Service Bulletin

E246

EPA2013 and EPA2017 PACCAR MX-13 and MX-11 Engine Mounted Fuel Filter Installation

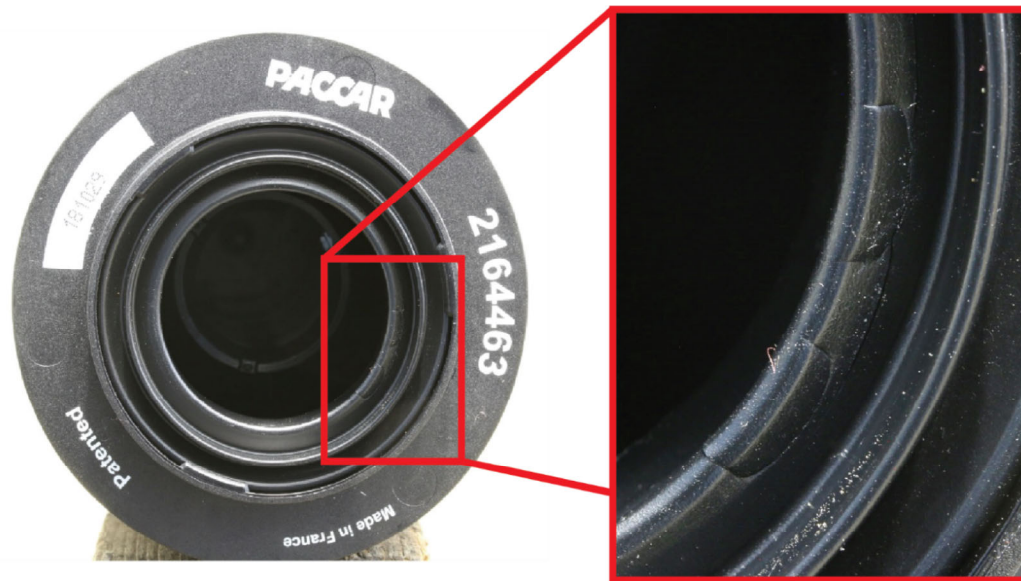
The following images show fuel filter damage typically caused by not lubricating the fuel filter seal and rotating it during installation. Notice the depressions and tears in the [seal](#).

Refer to the updated fuel filter installation procedures in Repair & Maintenance RMI.
